DPW NO. 23-332  
**BLACKFOOT READINESS CENTER**  
 260 RICH LANE  
 BLACKFOOT, IDAHO 83221  
 DEMOLITION FLOOR PLAN

Approved  
State of Idaho  
Division of Building Safety  
Date: 10/03/23  
PA#: BLD2307-00115

## COMMERCIAL PLAN REVIEW NOTES

**BLD2307-00115**

**MP1.1**

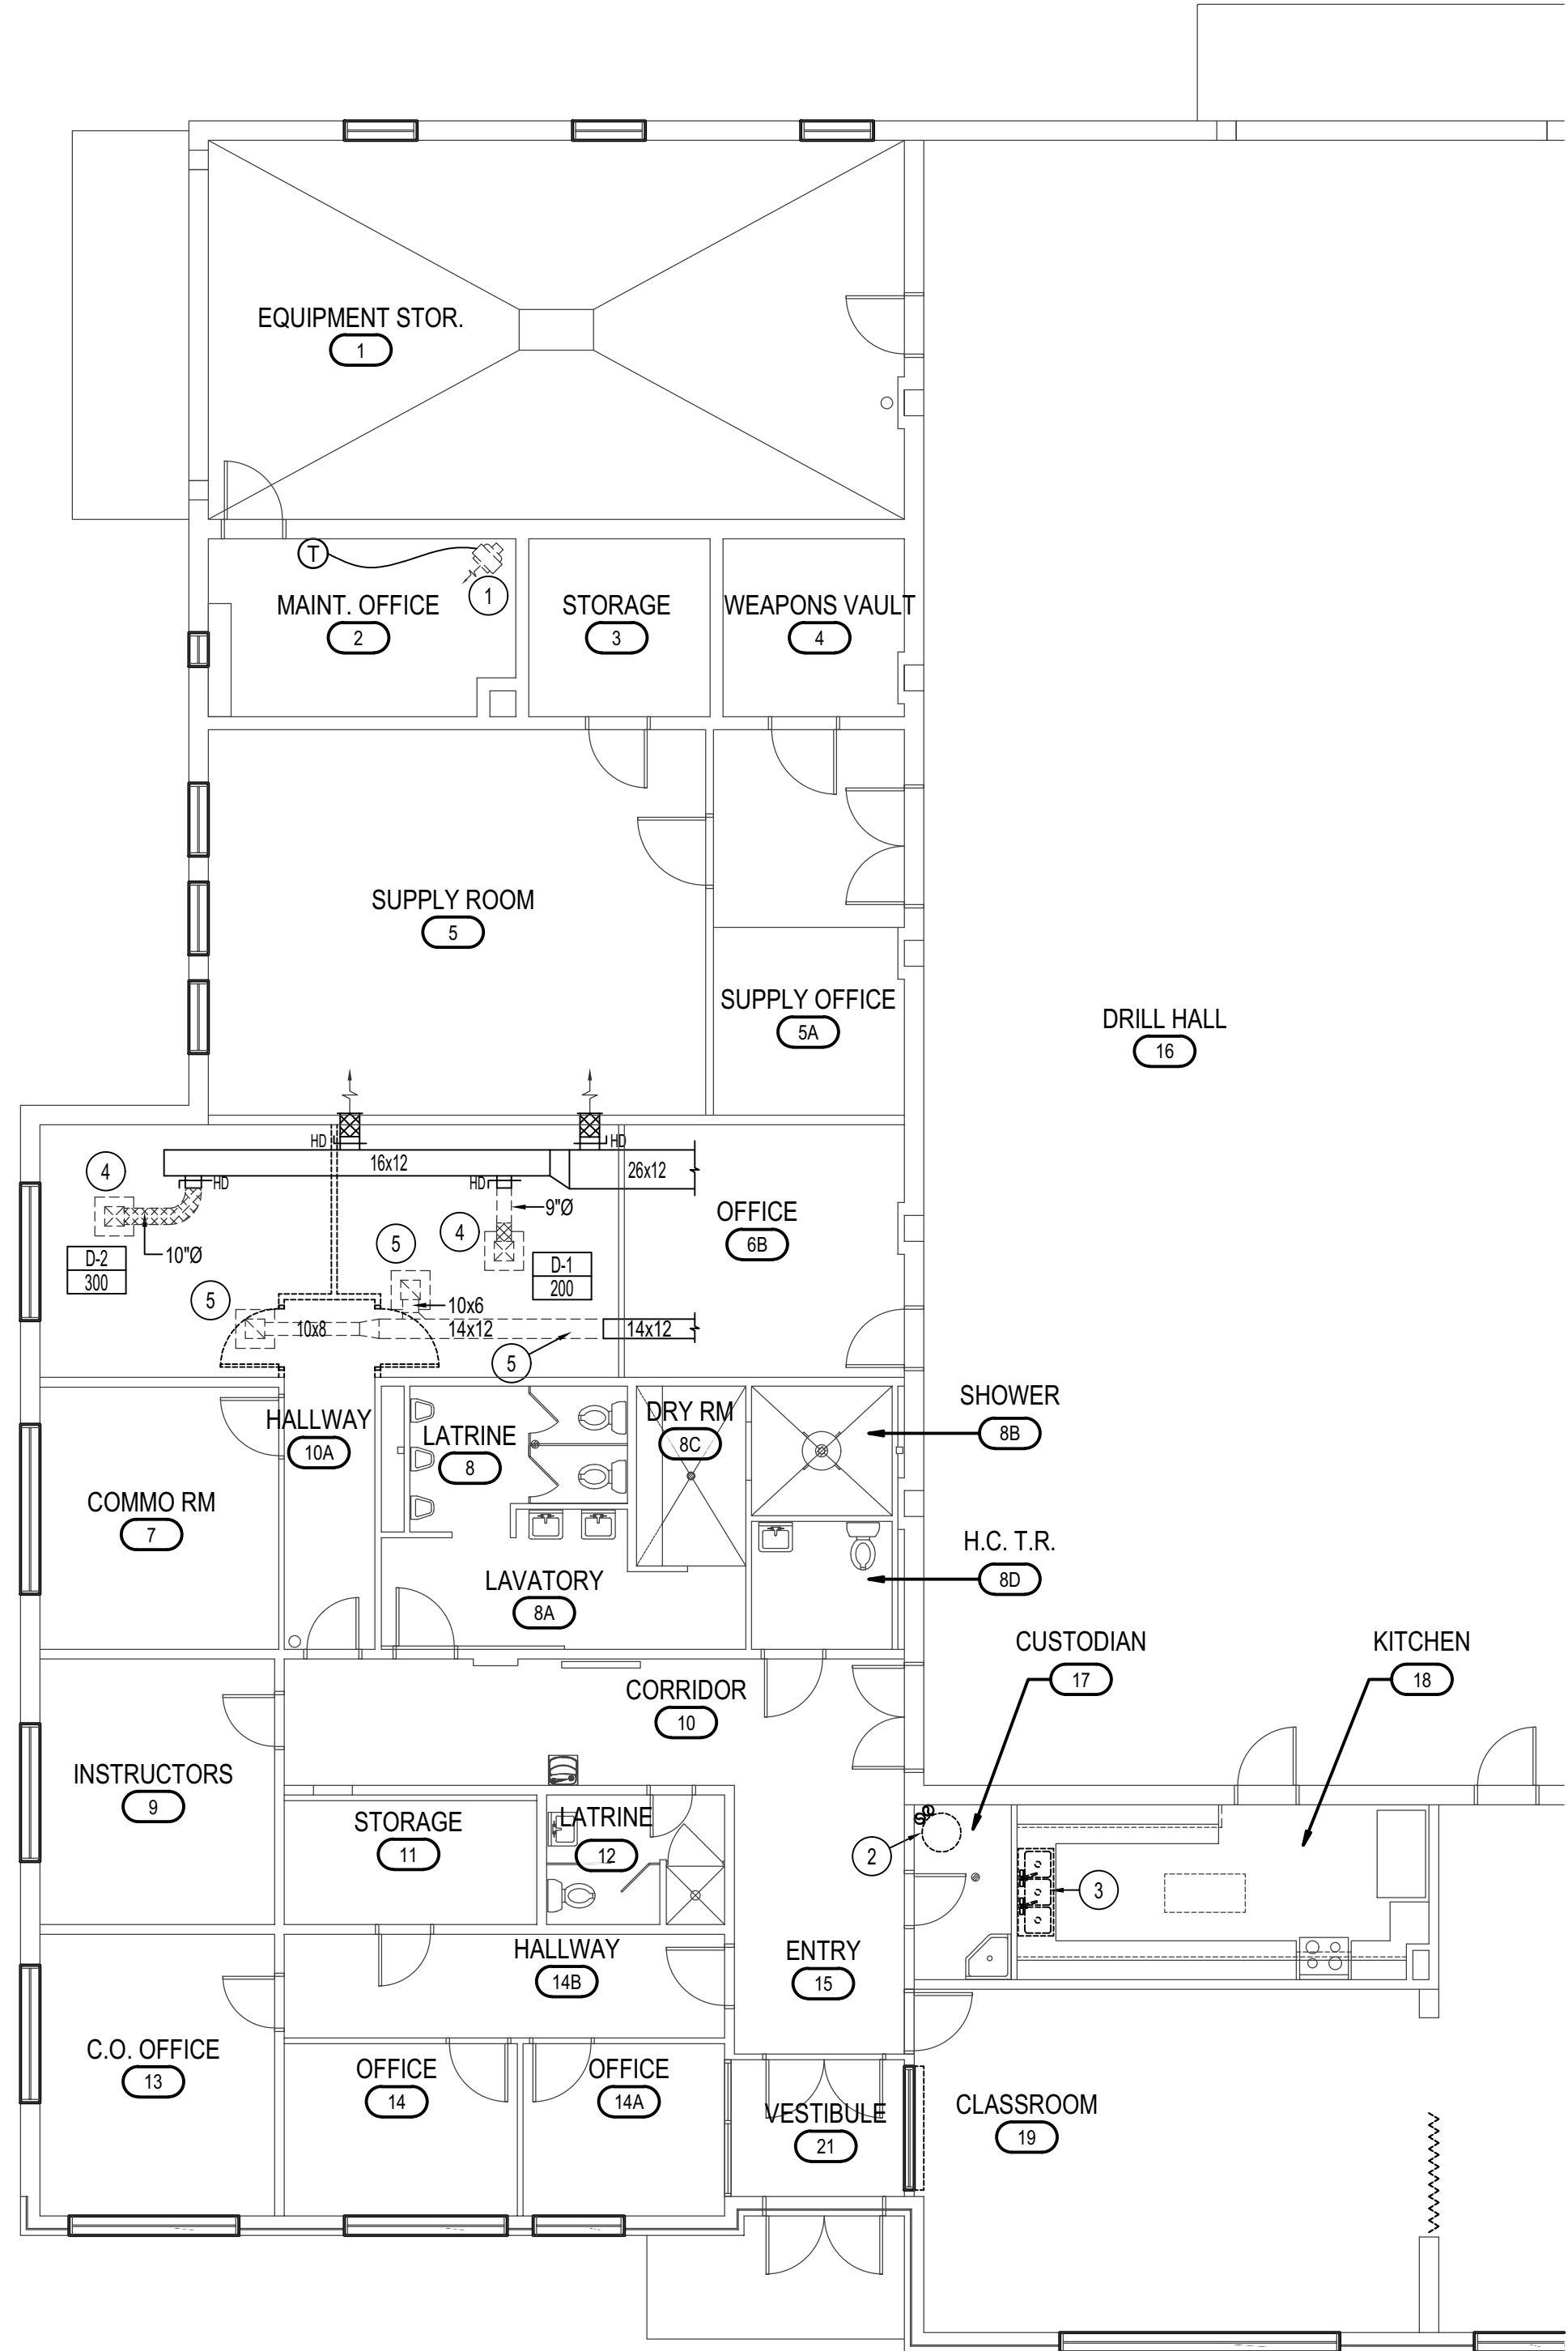
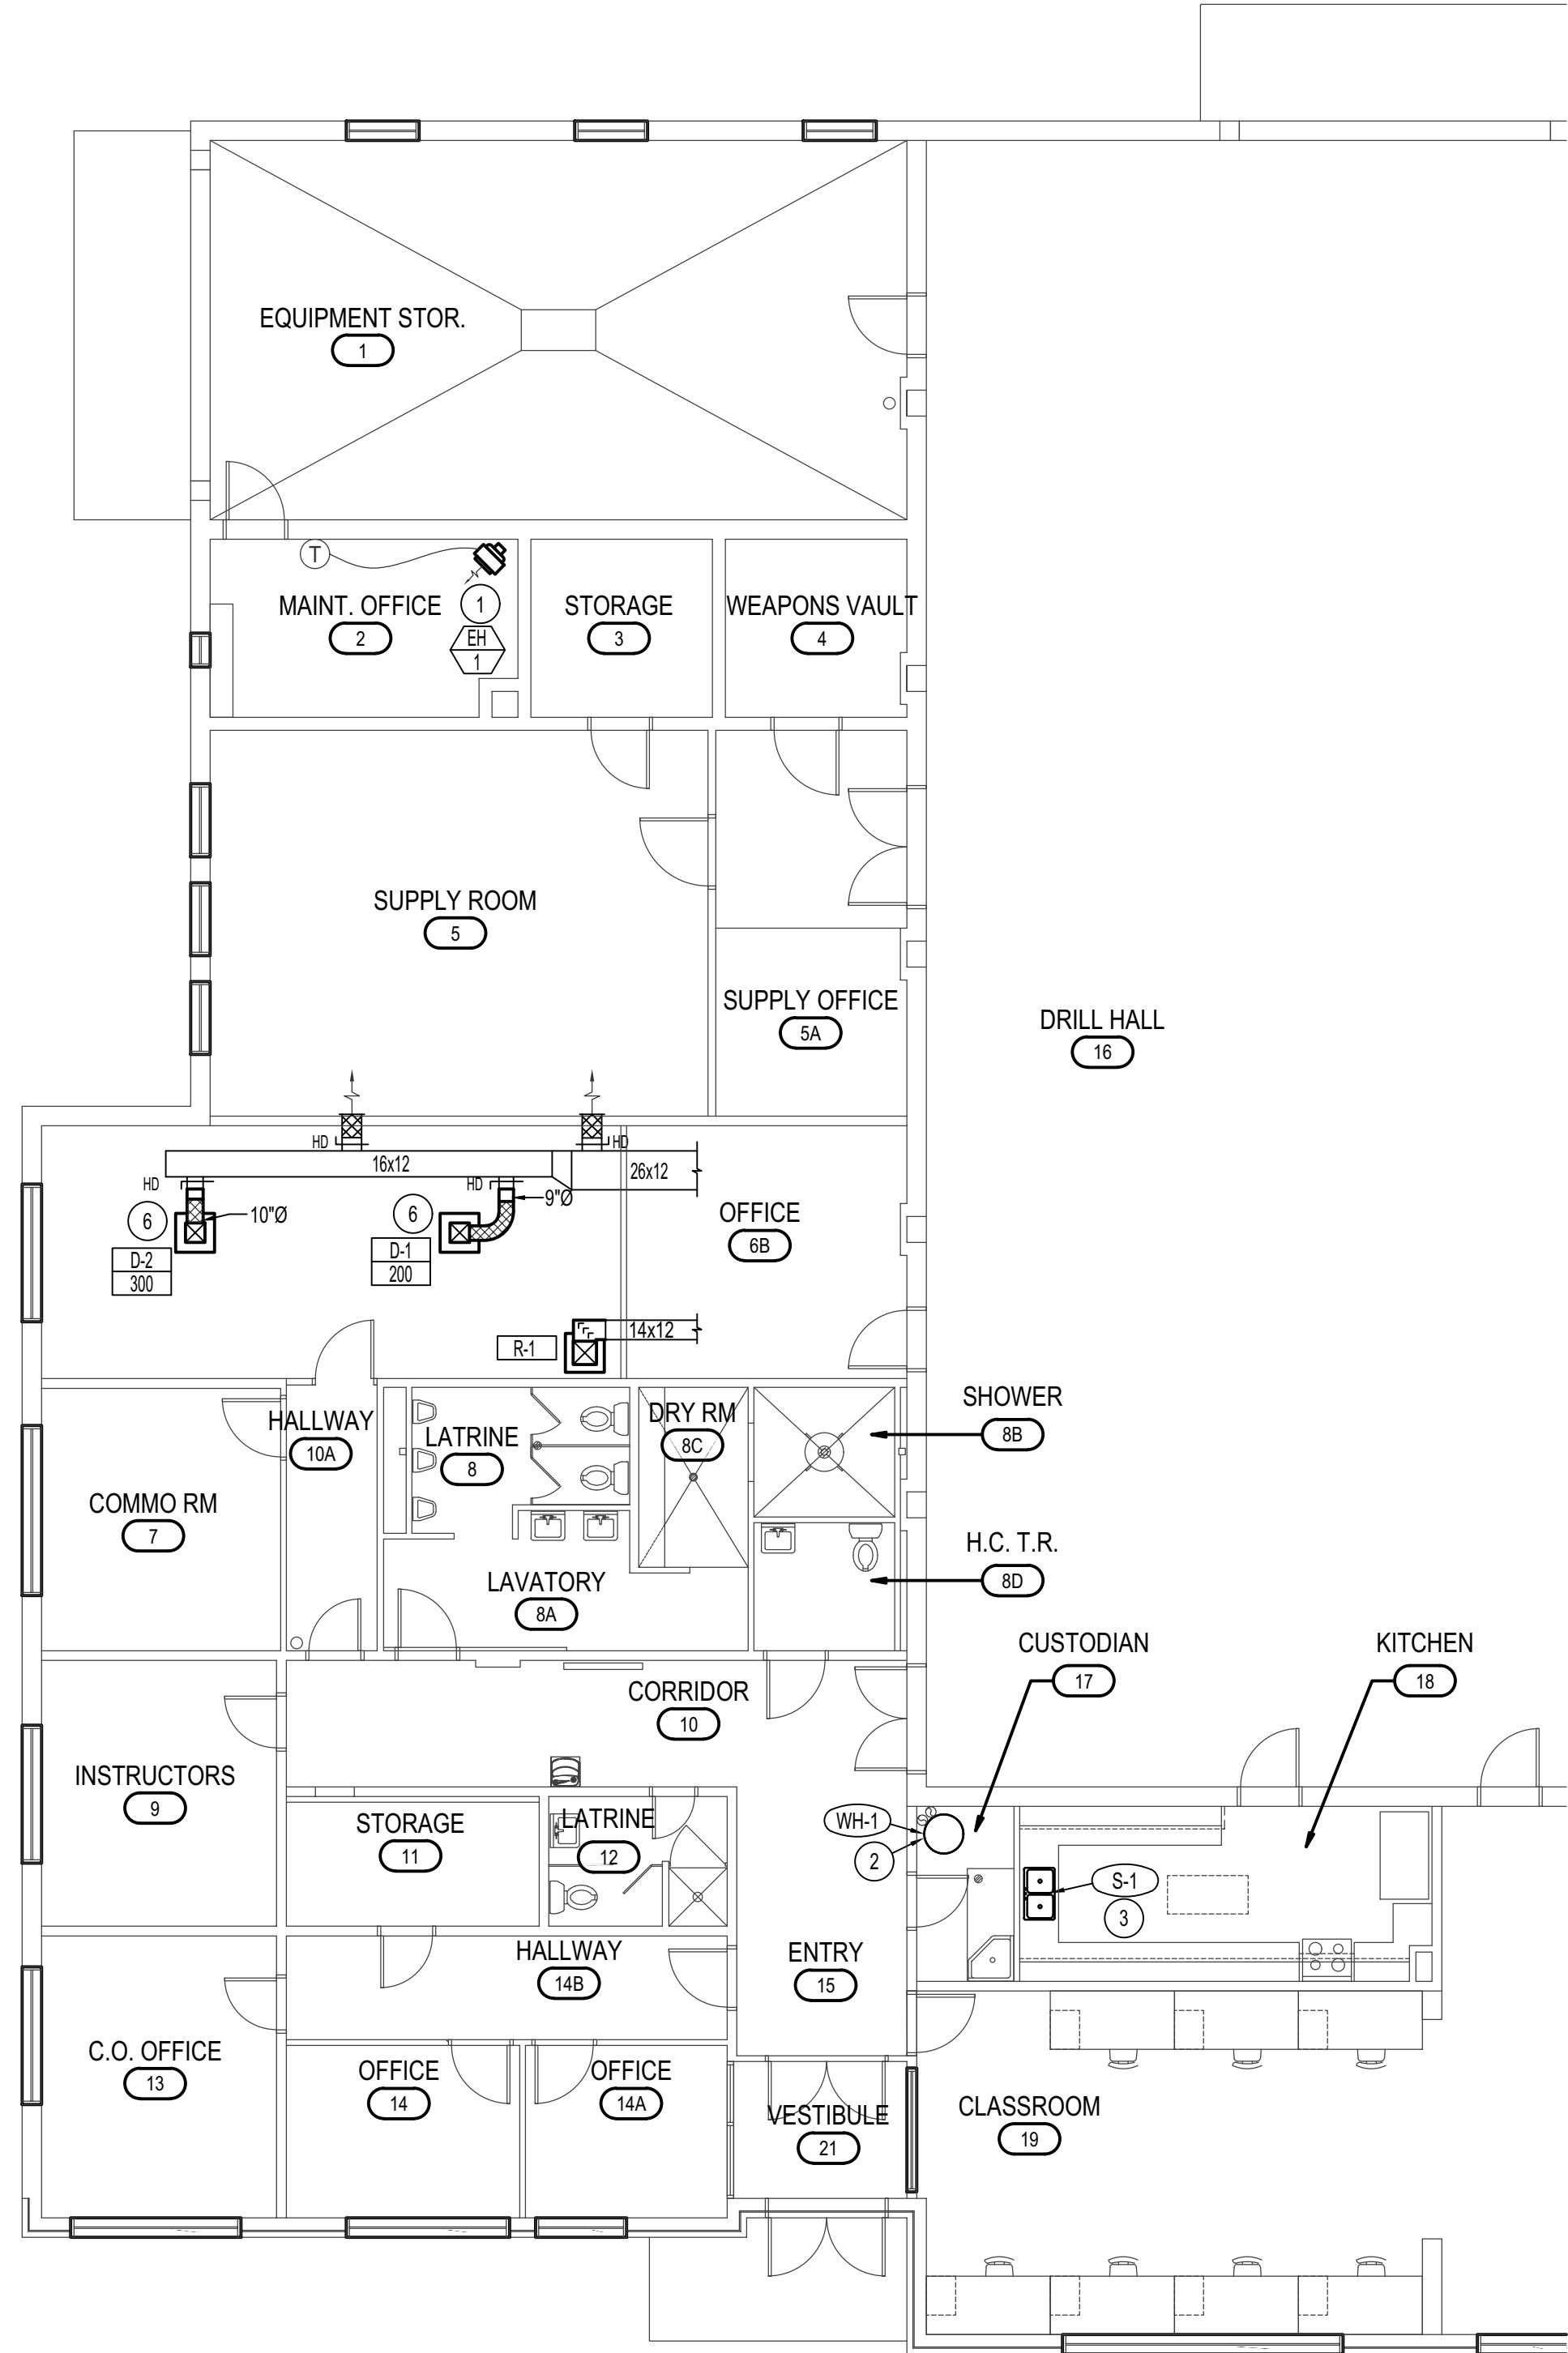
Approved  
 Plumbing Plan Review approved with conditions. Inspector to field verify for compliance with 2017 ISPC. Final approval is based upon inspection and shall adhere to the 2017 Idaho State Plumbing Code
